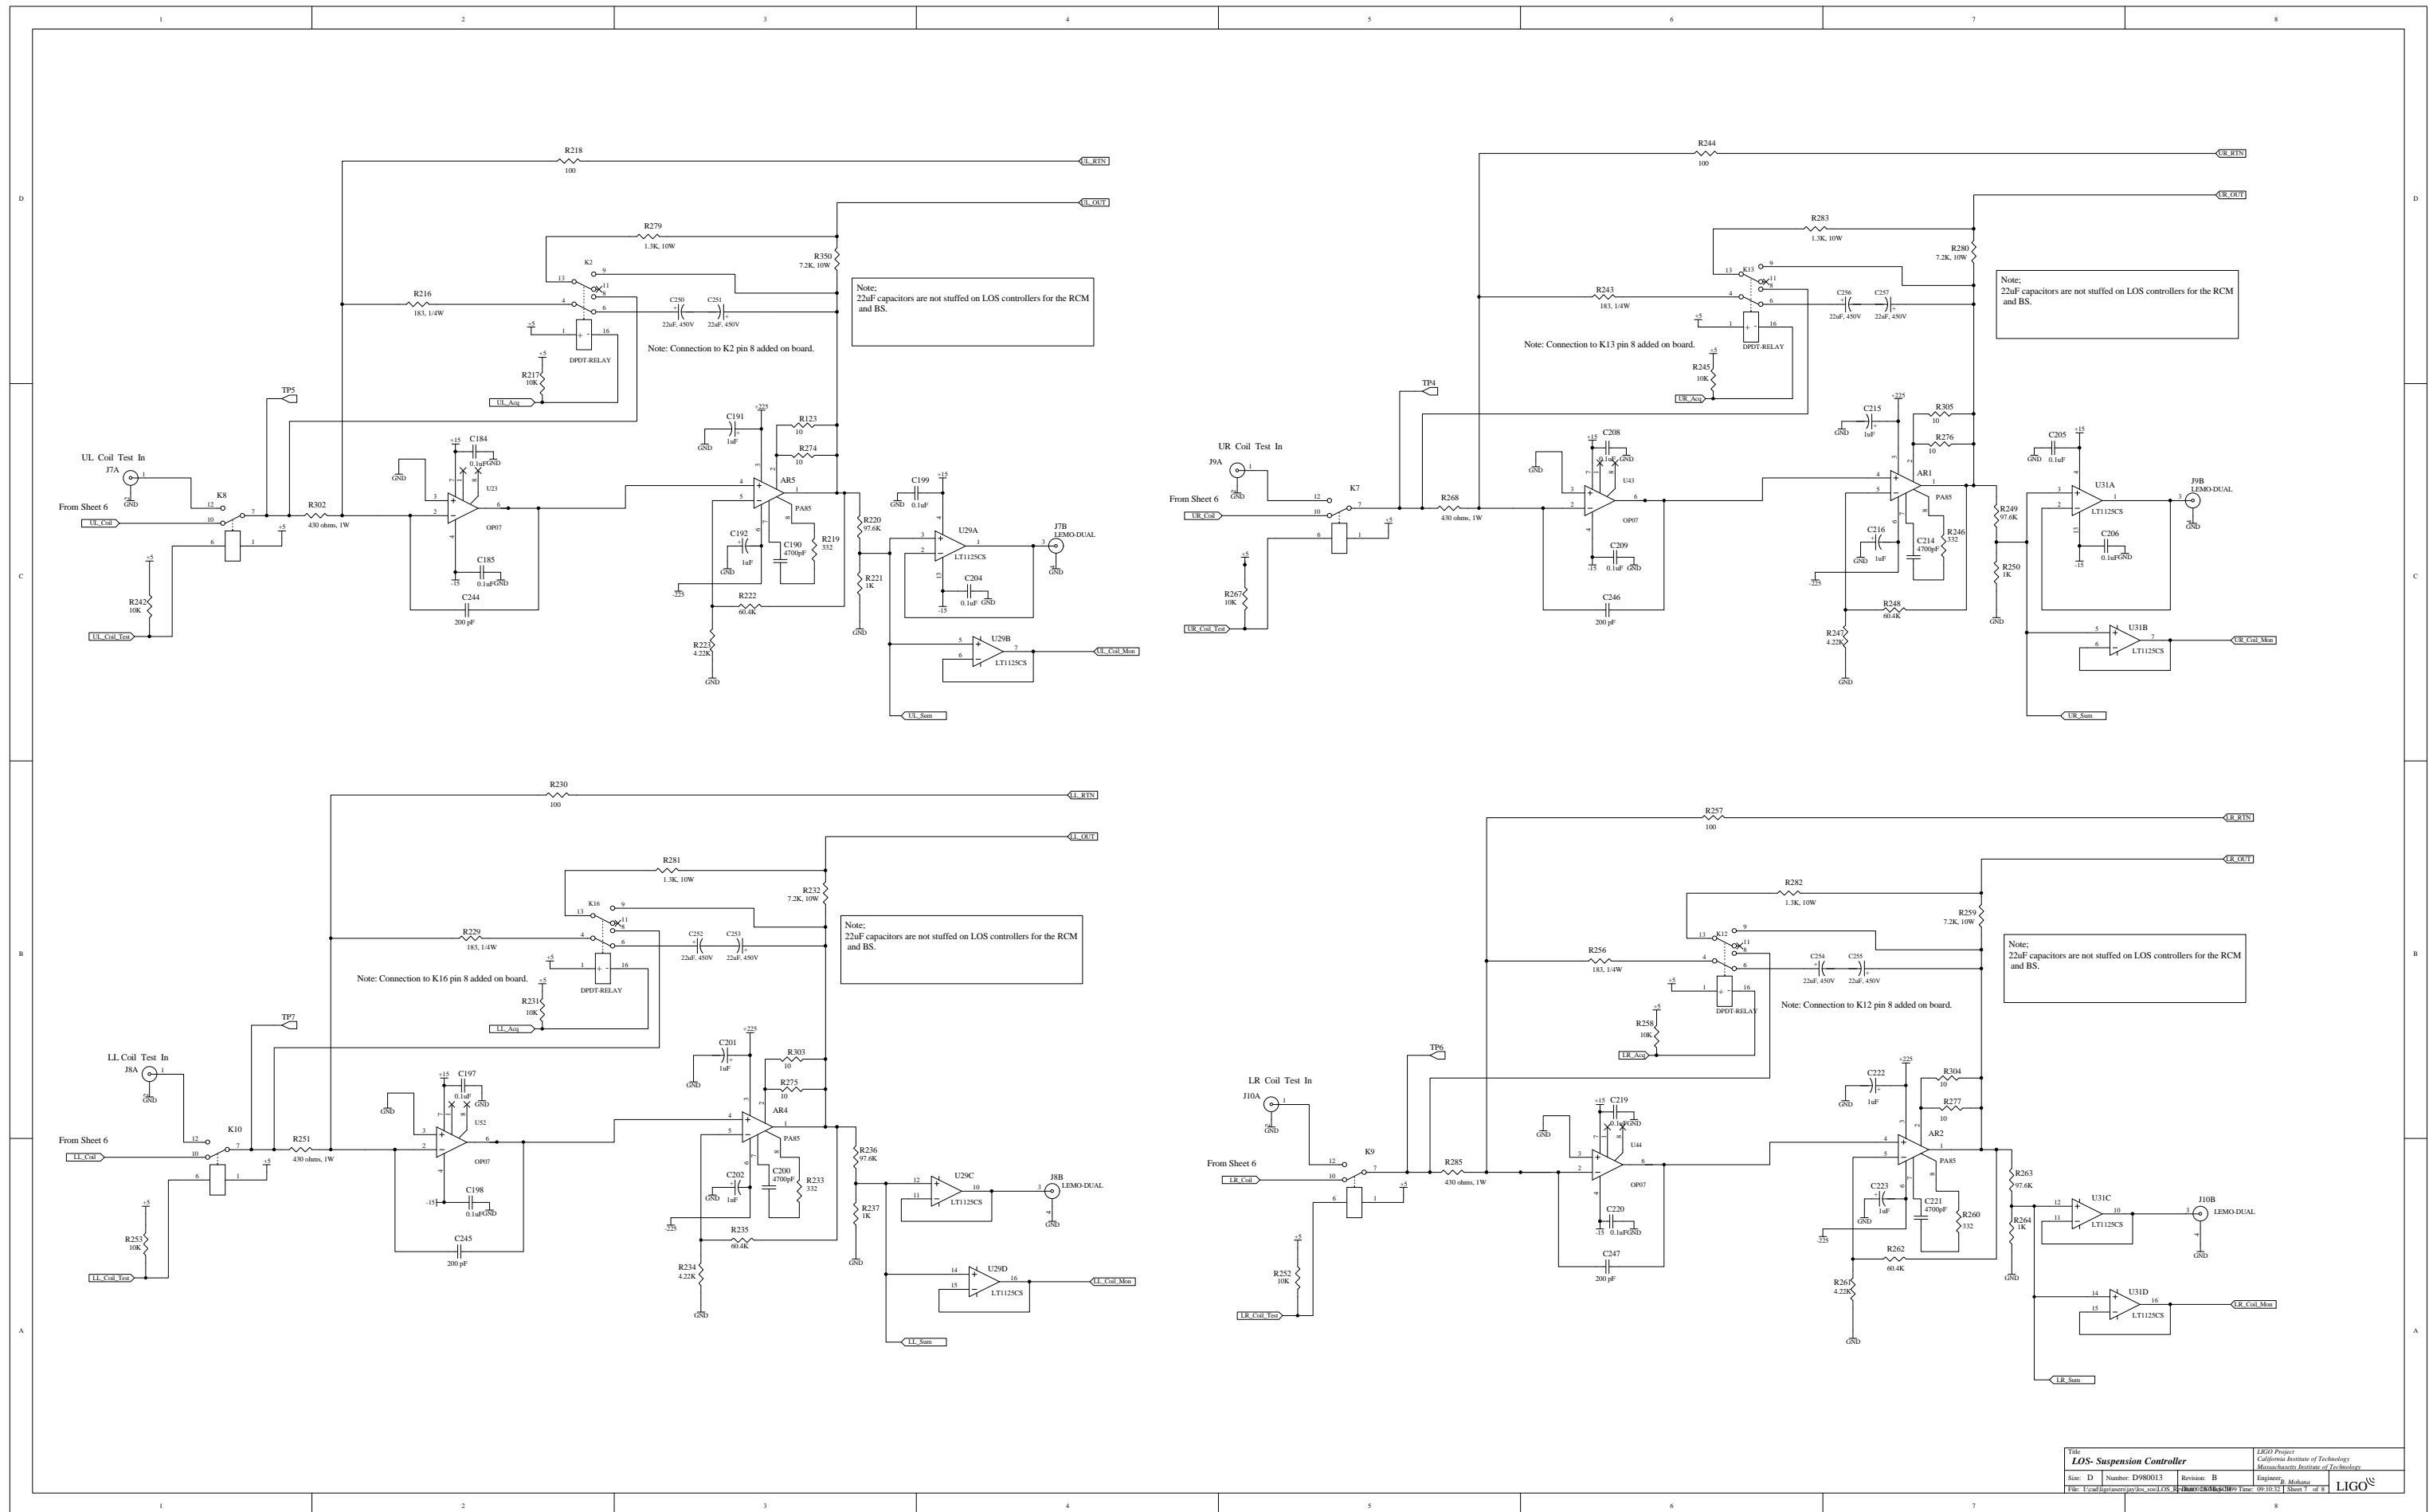
Note: Connection to K11 pin 8 added on board.

Note:
The wiring to the daughter card was changed after board manufacture. The actual connections to the board are made via wires to the coil driver outputs. The PD connections remain as shown.
An interface board (ref. D990022) is used for this function.
